April 29, 2024

Re: Comments on Draft Environmental Assessment for Dunlap Creek Vegetation Management Project

Thank you for the opportunity to comment on the Draft Environmental Assessment (“Draft EA”) for the proposed Dunlap Creek Vegetation Management Project (“the Project”). Please accept these comments on behalf of the Southern Environmental Law Center and the Virginia Wilderness Committee.

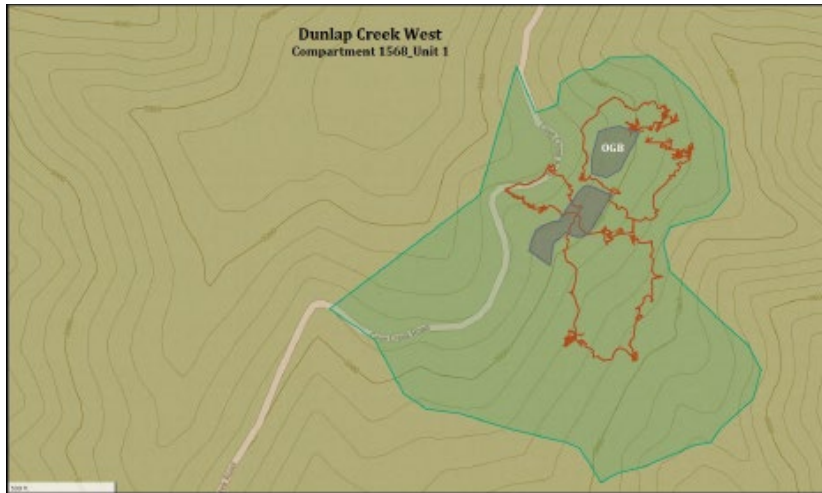
3. Shapes of the buffer boundaries seem overly constrained and by failing to incorporate individual old age trees located nearby (within 0-100’ of the boundary), do not seem to achieve the federal mandate to conserve existing old growth and mature forest.

Old age trees
southwest of the old
growth boundary.

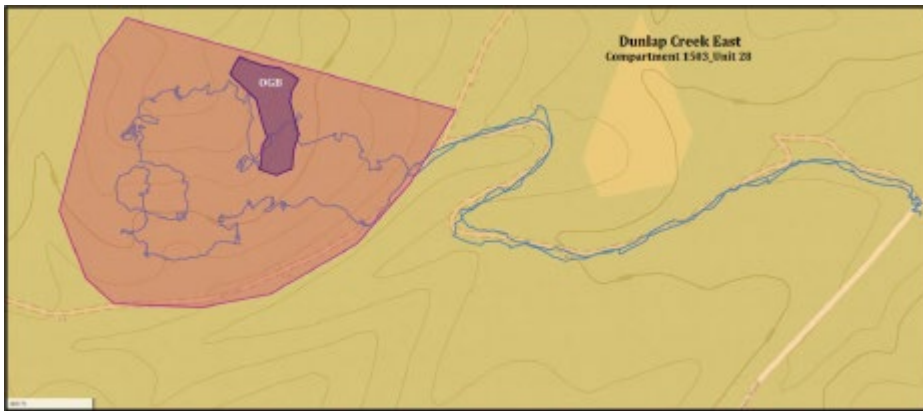
Old age trees were scattered with localized groupings, especially to the southwest of the old growth boundary. An area with a higher density of larger diameter, old age trees was found ~250' southwest of the southwest point of the old growth area (see photos below).

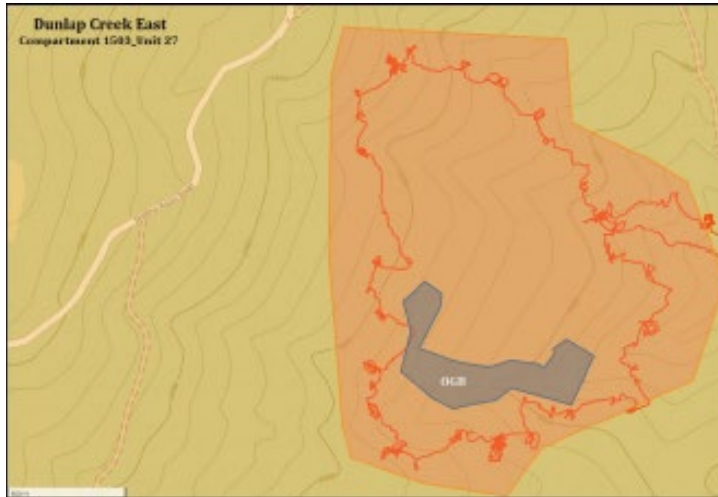
The old growth boundary was flagged. The area east of the boundary contained widely scattered old age chestnut oak and yellow pine with some scattered groupings. Mature/possibly old age yellow pine are present 100'+ outside the southwest old growth boundary in an area with old growth character.

Another area with old growth character that probably exceeded an acre was observed south of the old growth patch identified by the Forest Service. A 10.2" chestnut oak that looked old in this location tree was cored. A full core was not obtained because a rotten void was encountered, but the 3.2" inch core section had over 100 rings. The Forest Service should visit Unit 28 again and determine if the boundary should be extended.
